OVERLOOK AT HOMESTEAD FILING NO. 1
 EL PASO COUNTY, COLORADO
 CONSTRUCTION DOCUMENTS
 GENERAL NOTES

PRELIMINARY
 FOR REVIEW ONLY
 NOT FOR
 CONSTRUCTION

TYPICAL SECTION (E)	
ROADWAY	STATION
APEX RANCH ROAD	4+80 - 12+30
CAMPOUT DRIVE	1+00 - 15+15

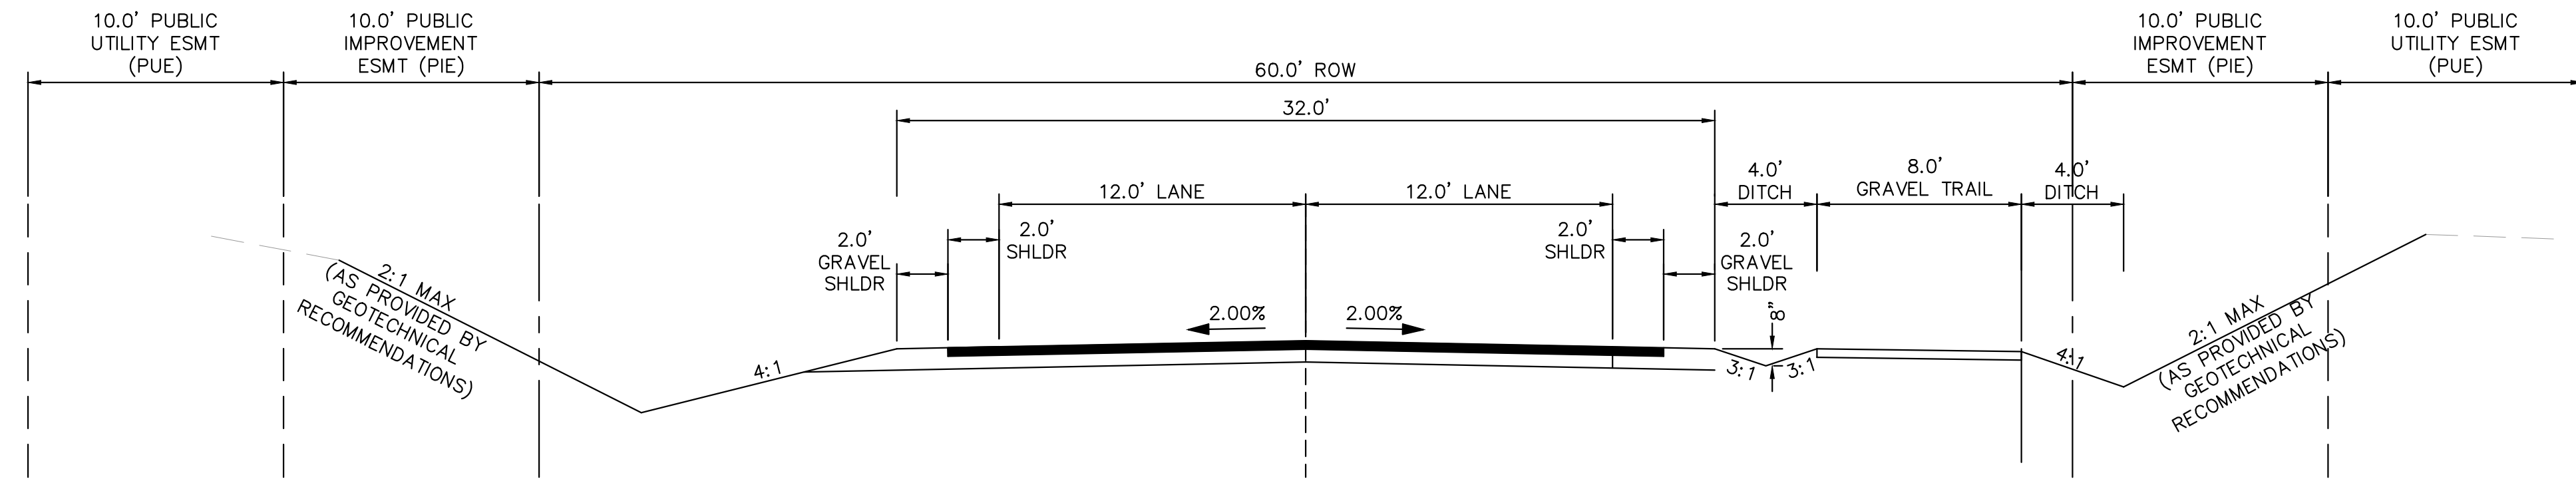
Please submit a deviation for the non-standard roadway section as indicated in previous correspondence

OVERLOOK AT HOMESTEAD FILING NO. 1
EL PASO COUNTY, COLORADO
CONSTRUCTION DOCUMENTS
APEX RANCH ROAD PLAN AND PROFILE

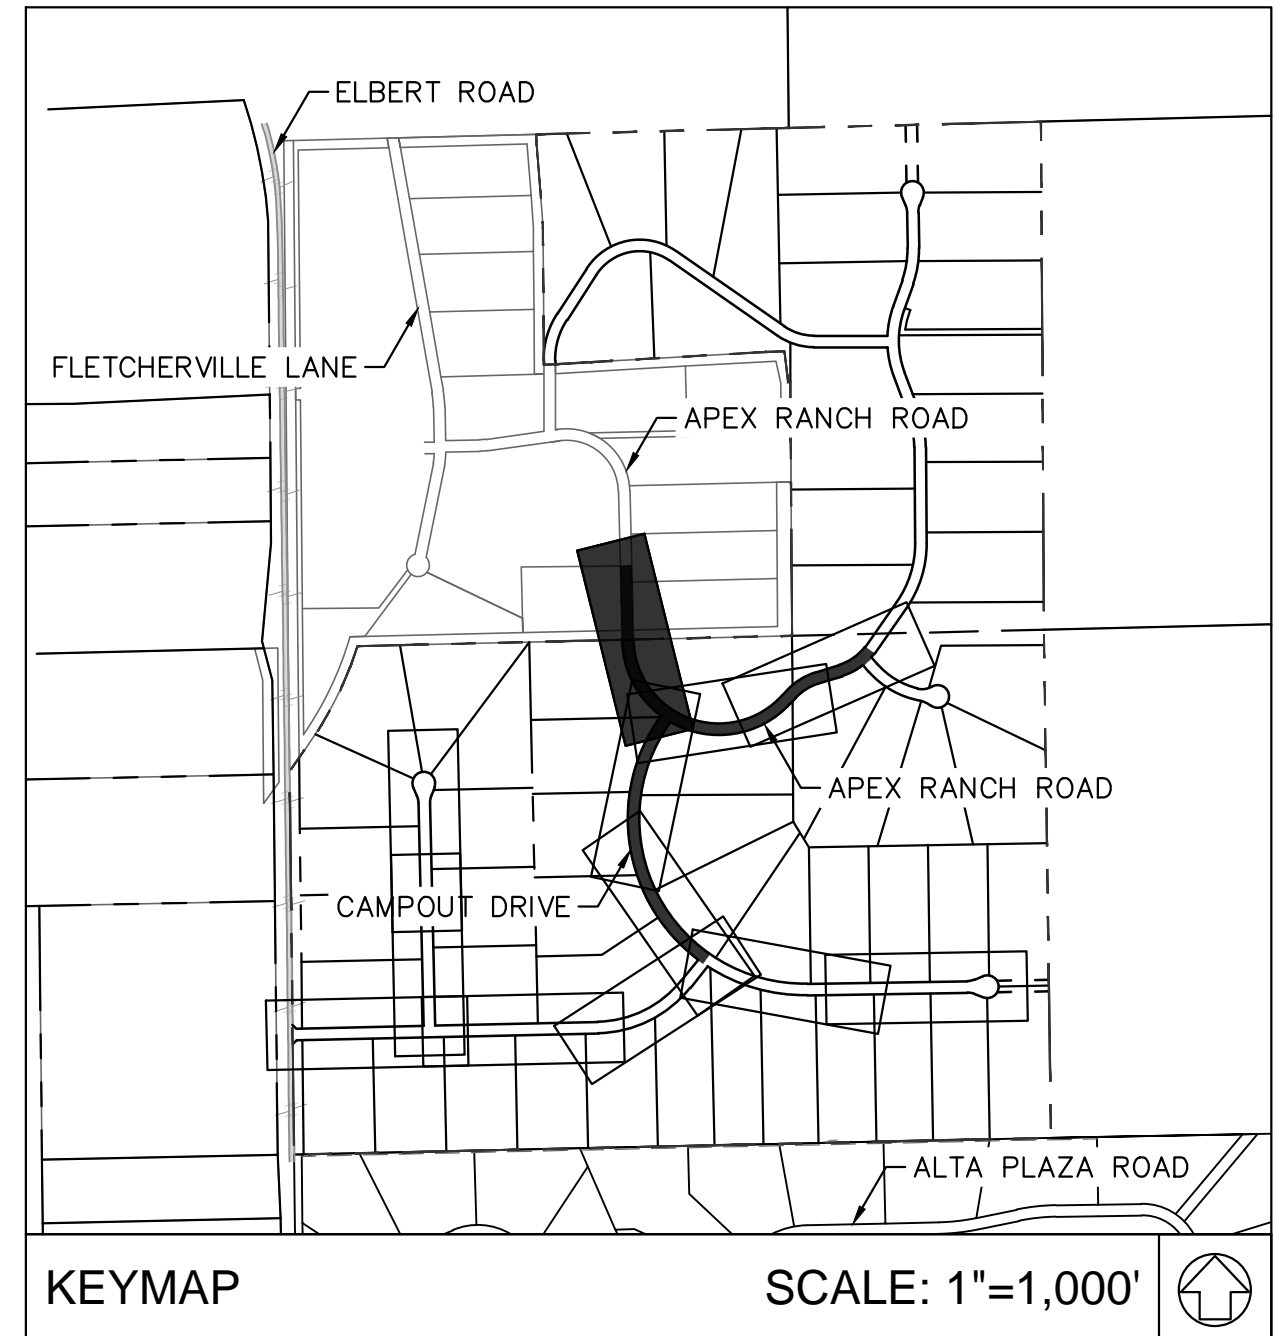
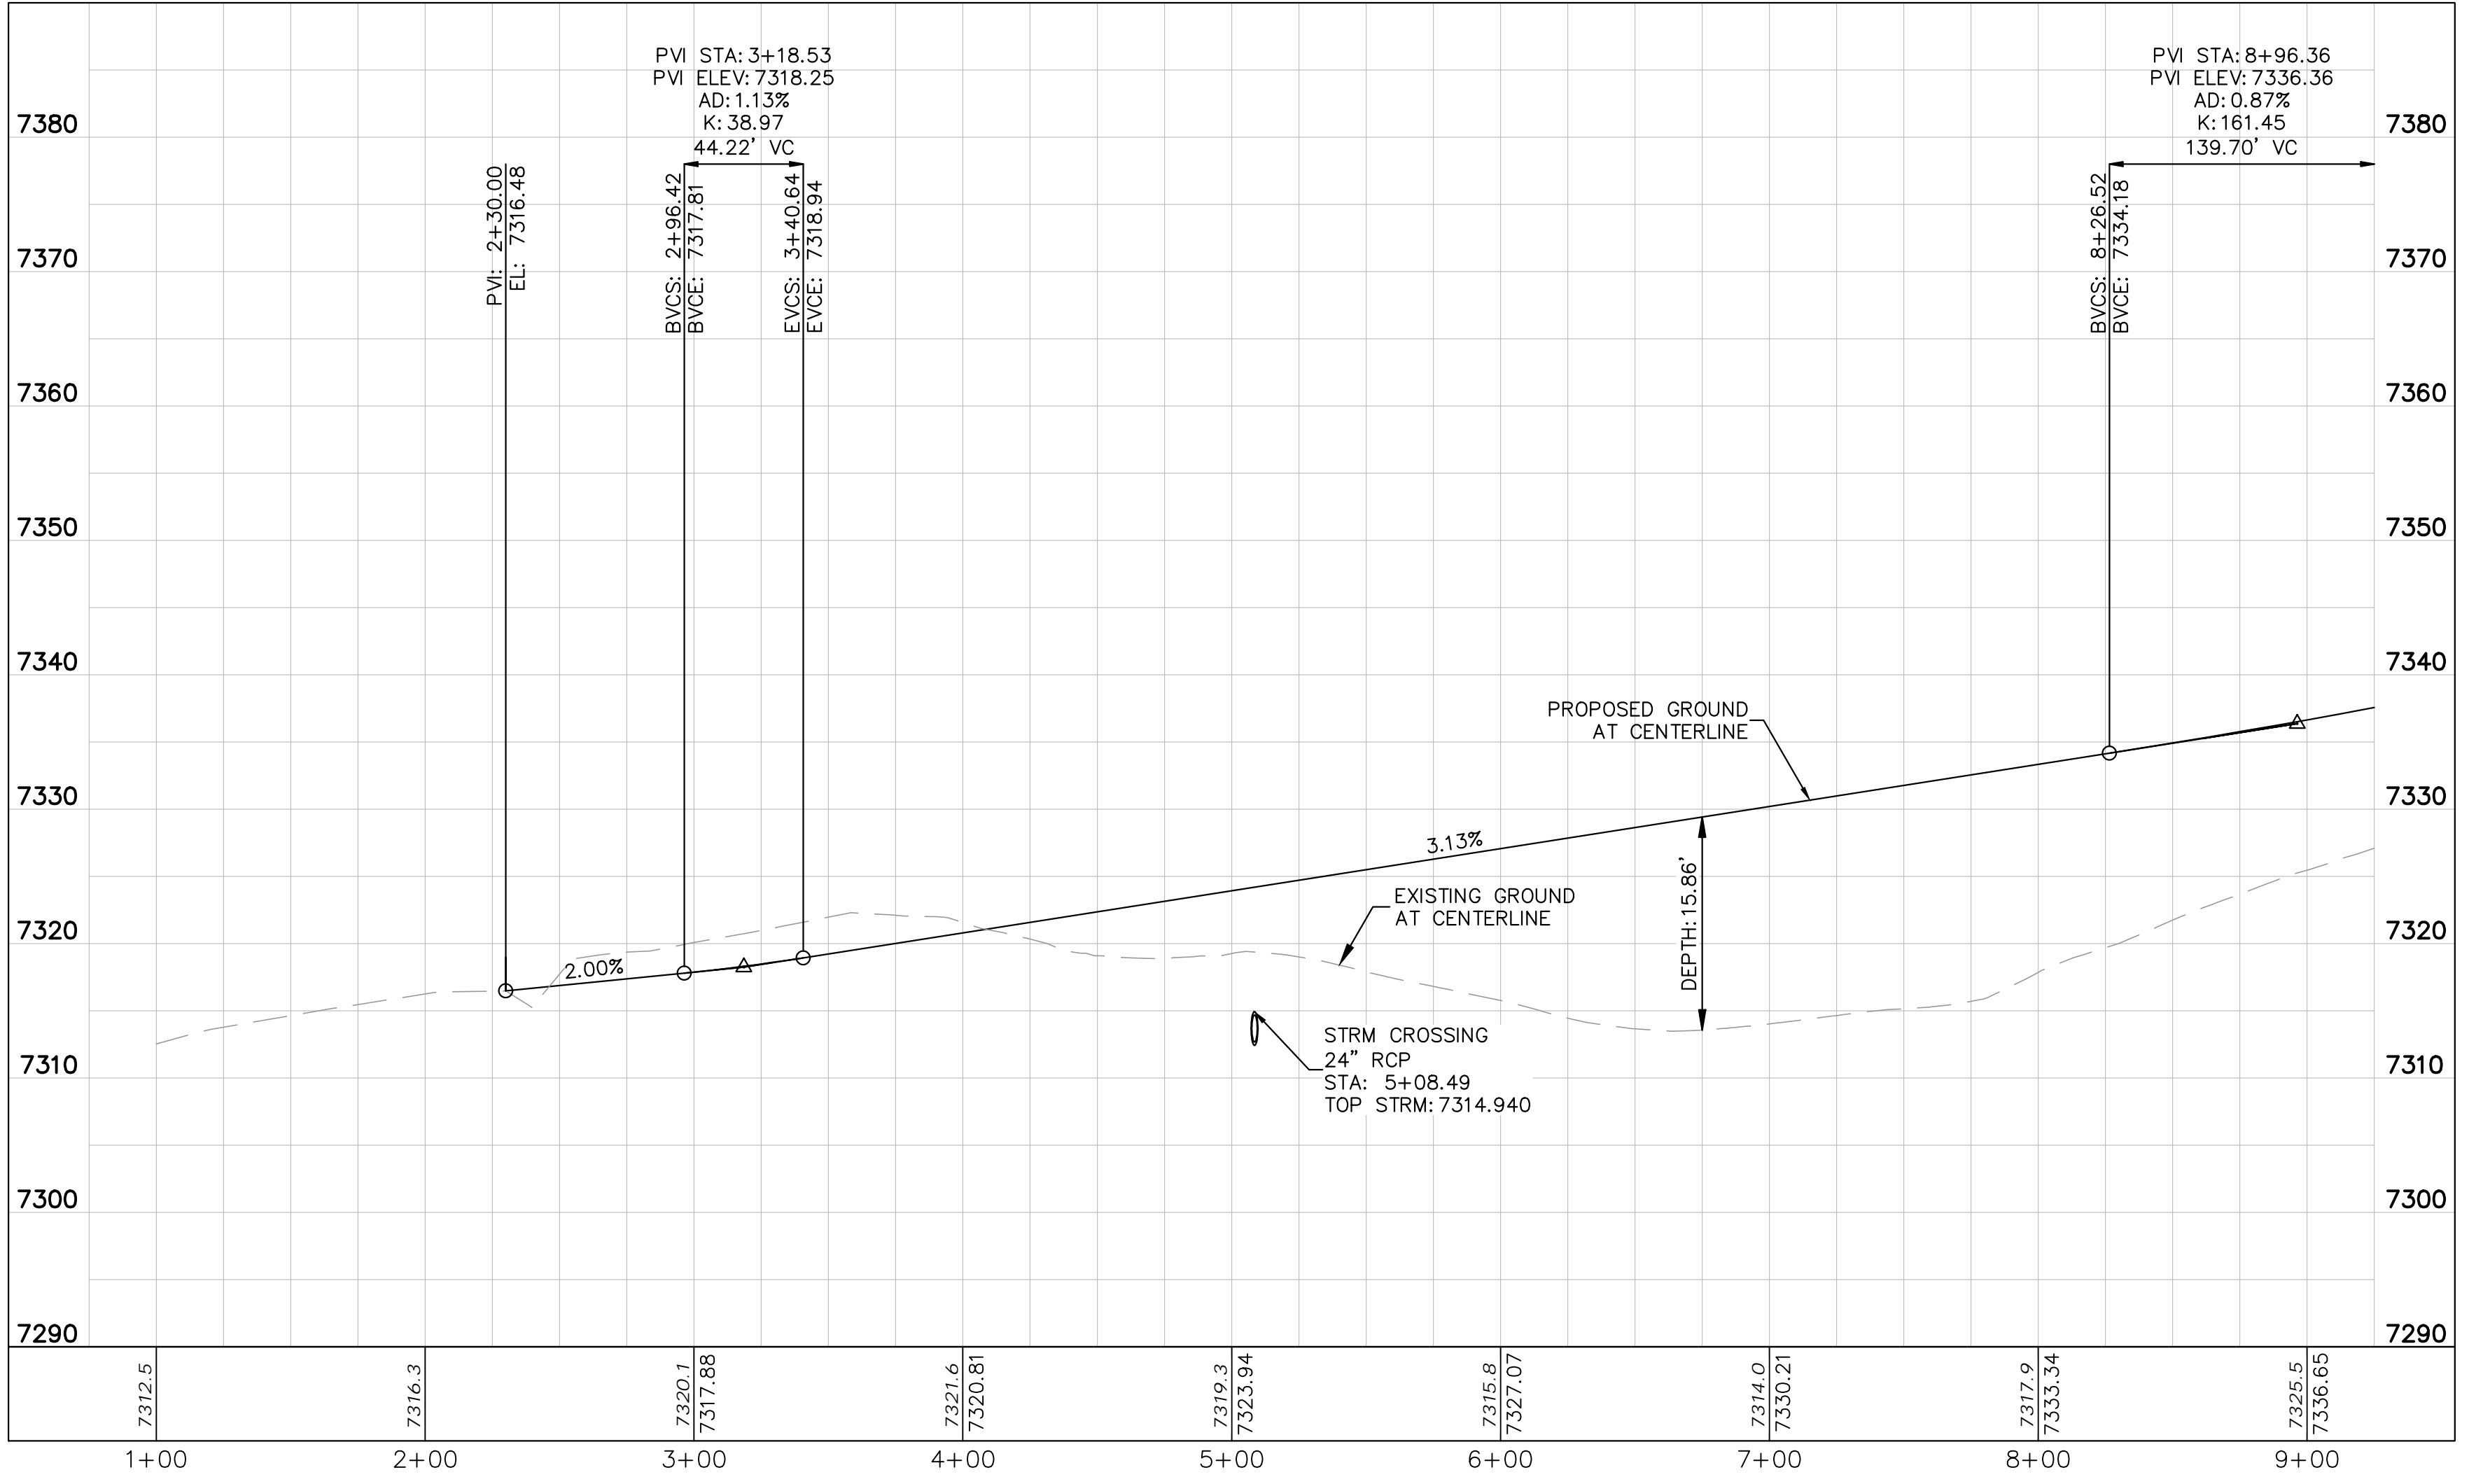
The highlighted portions of the cul-de-sac is a temporary easement. Restoration of Apex Ranch Road to a standard cross section is this developers responsibility per ECM 2.3.8.C. Please revise to show the work to be done to restore to a standard cross section.

OVERLOOK AT HOMESTEAD FILING NO. 1
EL PASO COUNTY, COLORADO
CONSTRUCTION DOCUMENTS
HATBAND DRIVE PLAN AND PROFILE

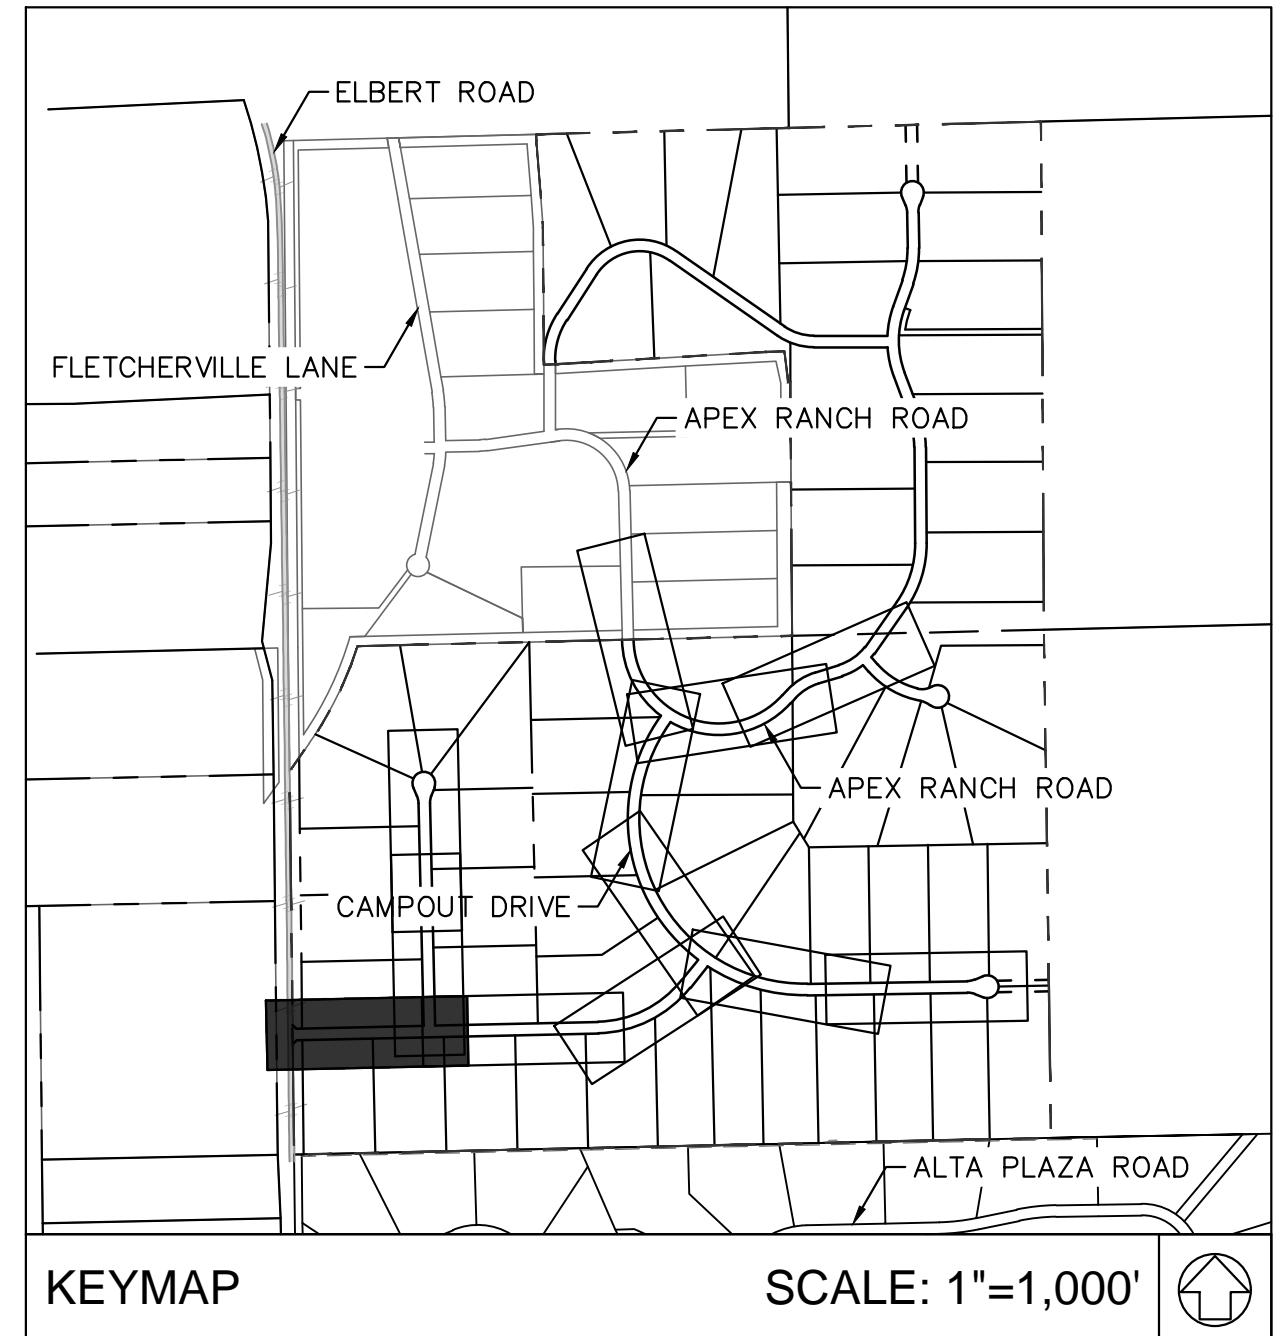
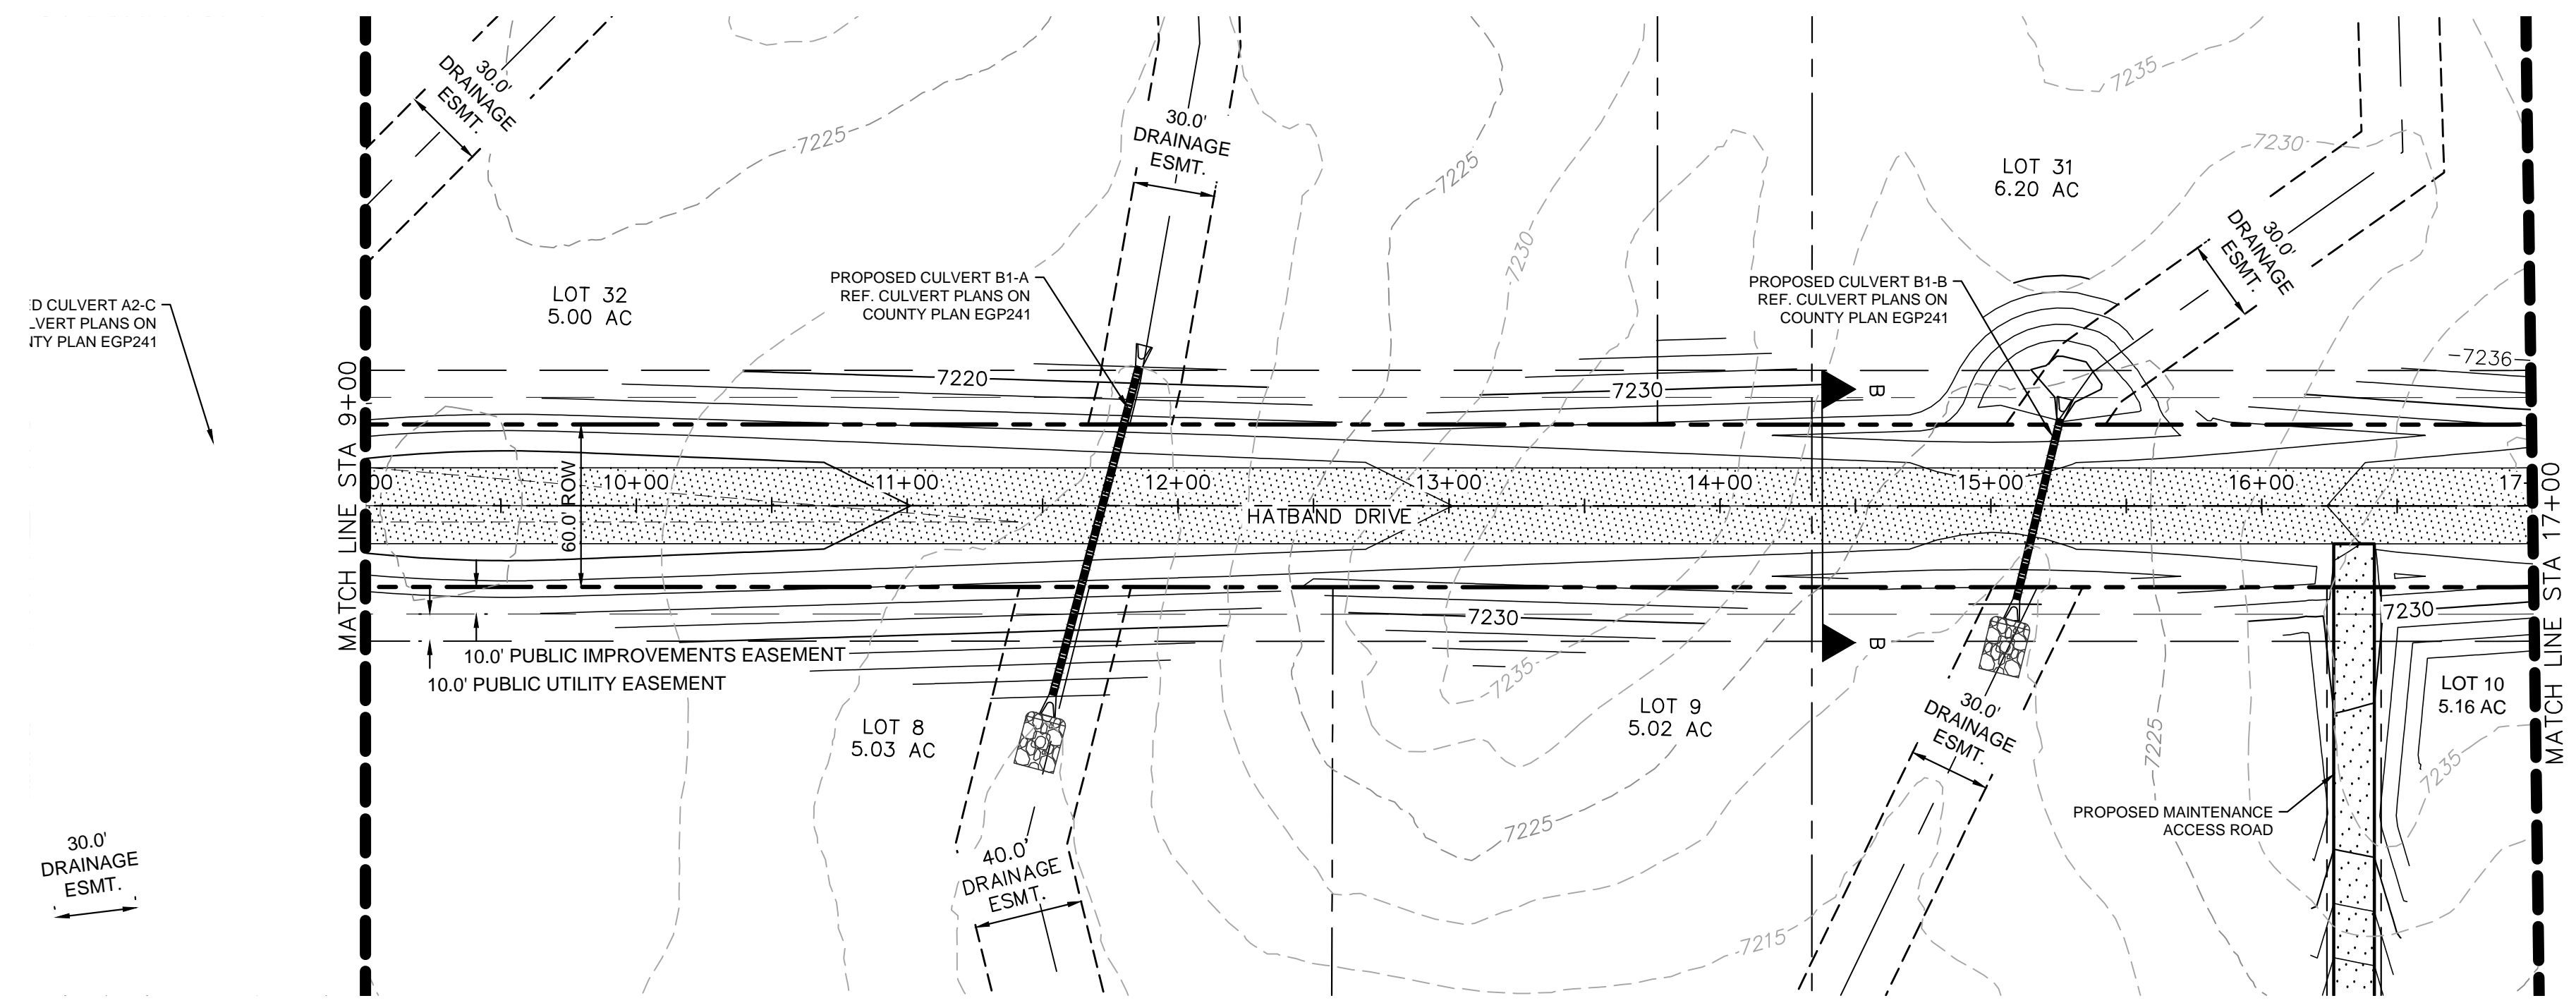
Please show clearance. Burial depth must be at least 2ft.
